Lake Oswego  
Public Golf  
Course

Stafford Rd

2/22/2023

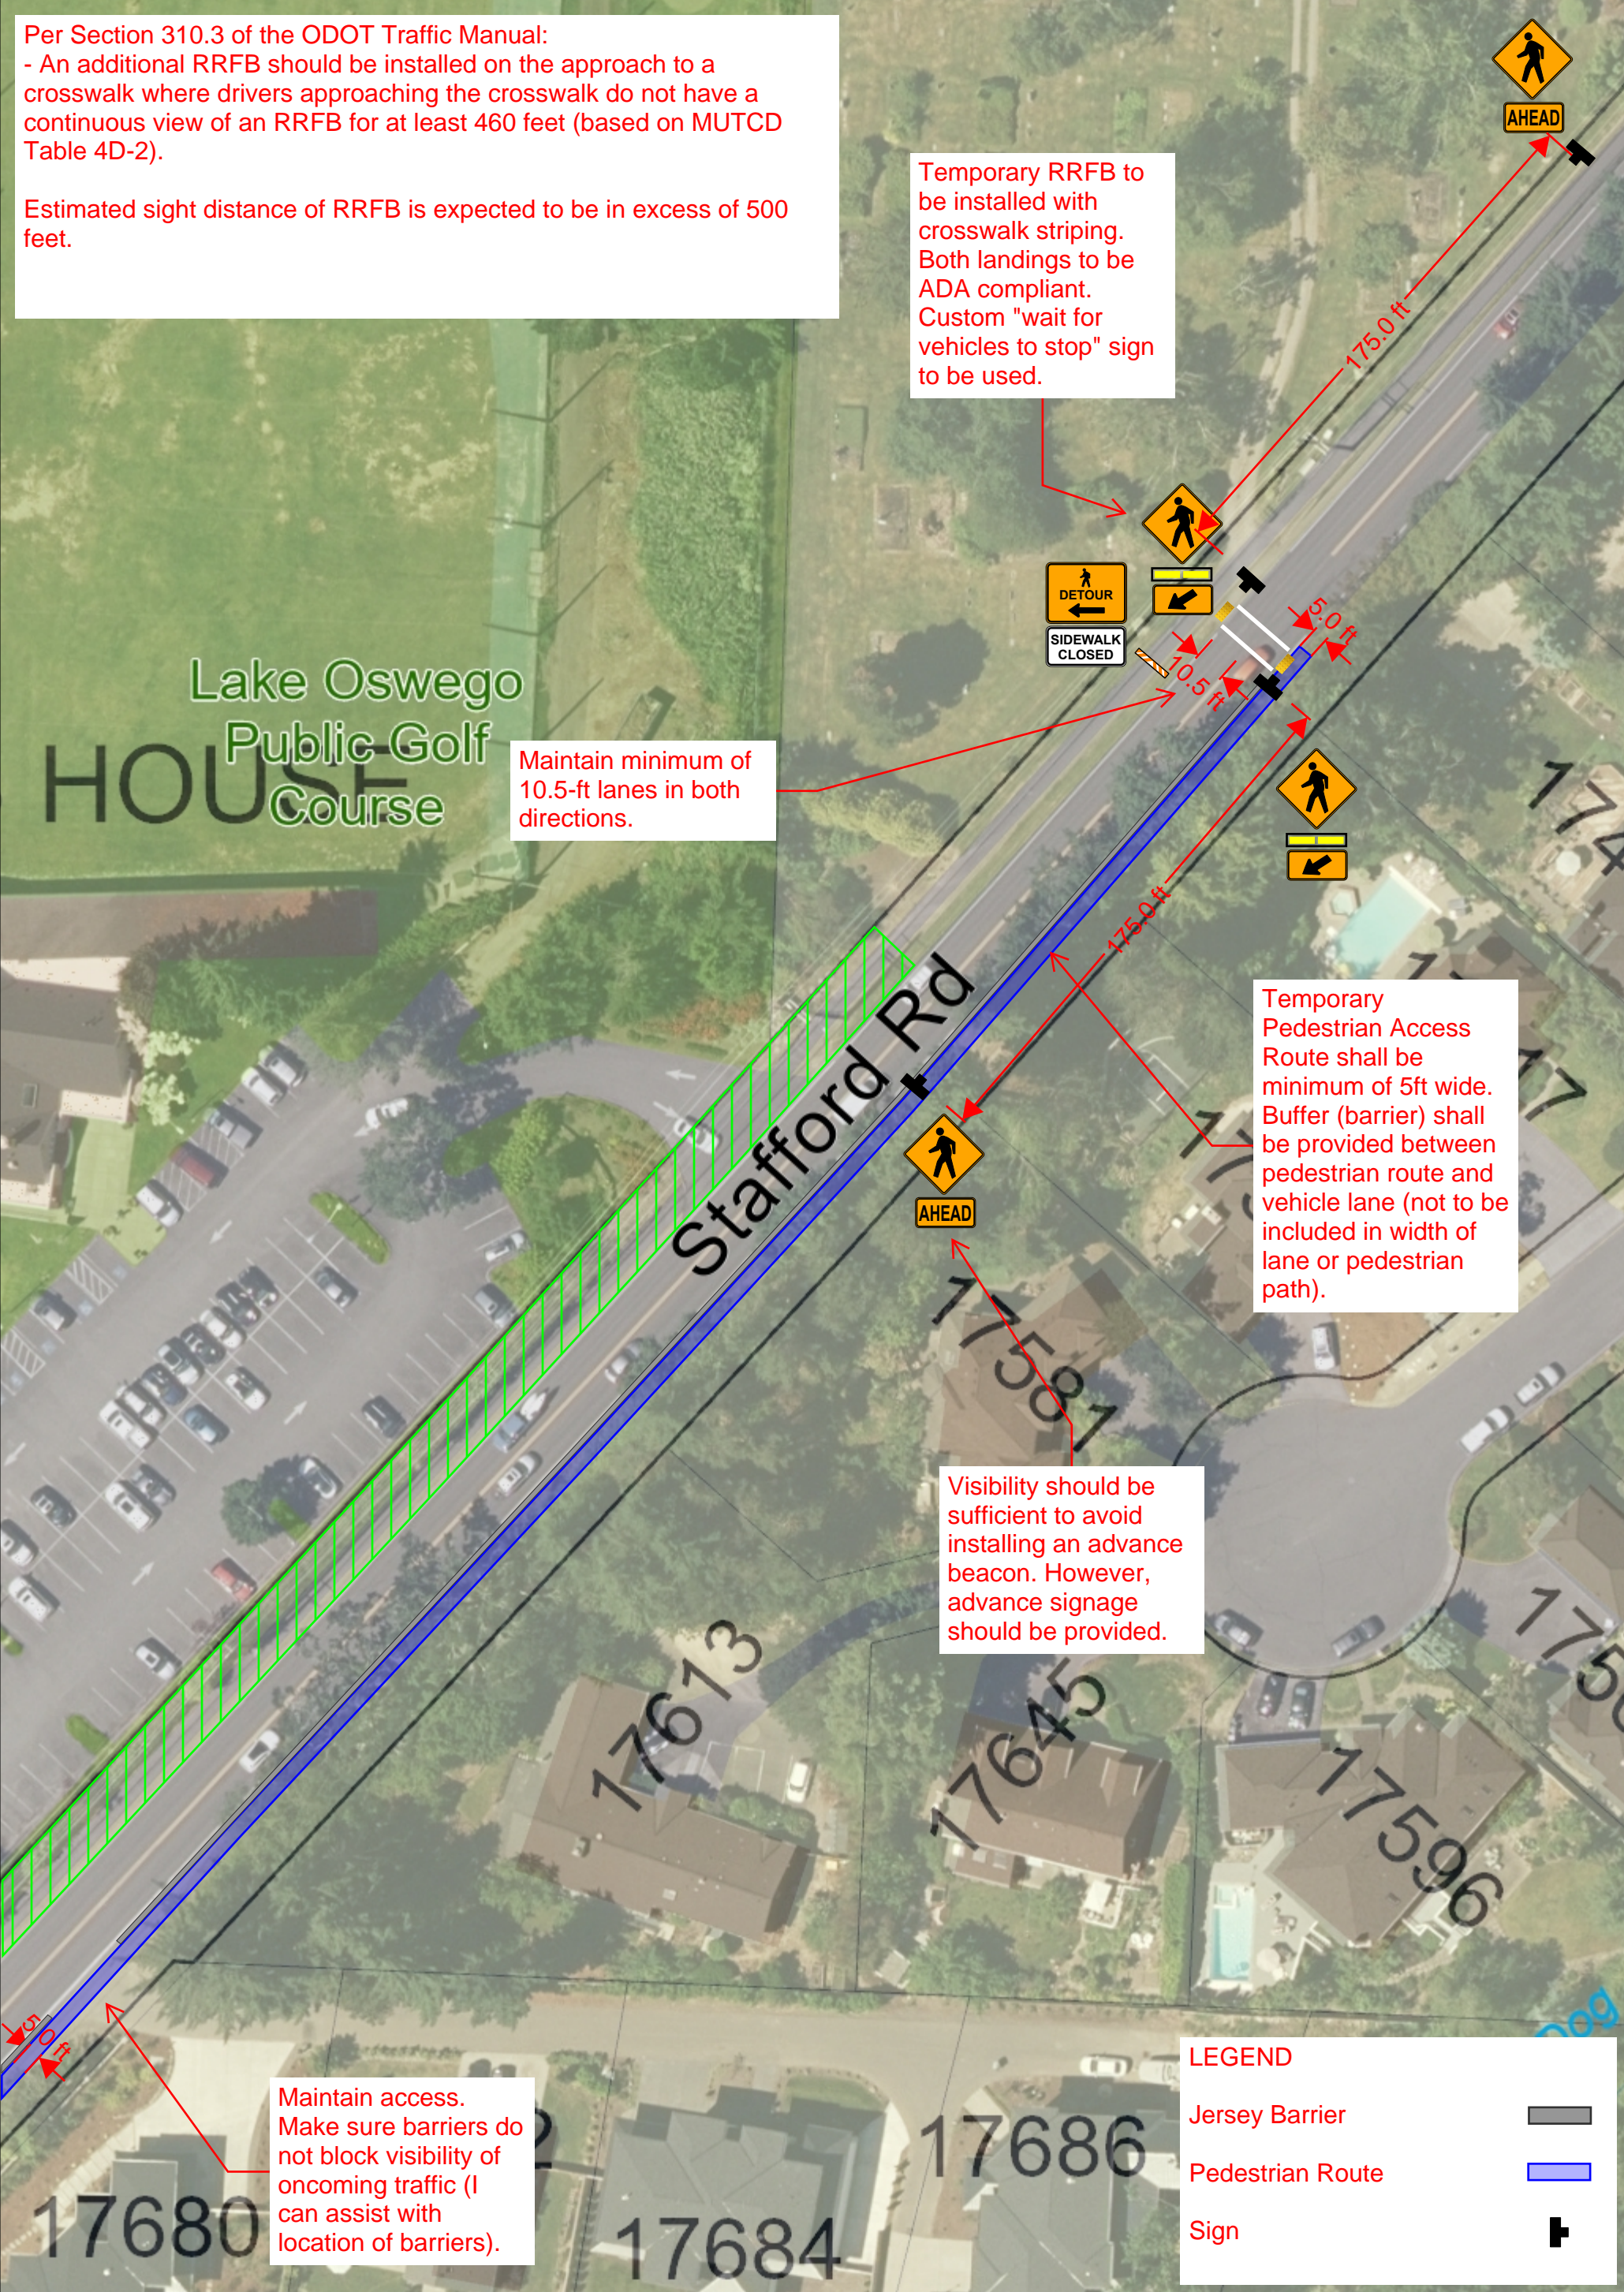
Per Section 310.3 of the ODOT Traffic Manual:  
 - An additional RRFB should be installed on the approach to a crosswalk where drivers approaching the crosswalk do not have a continuous view of an RRFB for at least 460 feet (based on MUTCD Table 4D-2).

Estimated sight distance of RRFB is expected to be in excess of 500 feet.

Temporary RRFB to be installed with crosswalk striping. Both landings to be ADA compliant. Custom "wait for vehicles to stop" sign to be used.

Maintain minimum of 10.5-ft lanes in both directions.

Temporary Pedestrian Access Route shall be minimum of 5ft wide. Buffer (barrier) shall be provided between pedestrian route and vehicle lane (not to be included in width of lane or pedestrian path).

Visibility should be sufficient to avoid installing an advance beacon. However, advance signage should be provided.

Maintain access. Make sure barriers do not block visibility of oncoming traffic (I can assist with location of barriers).
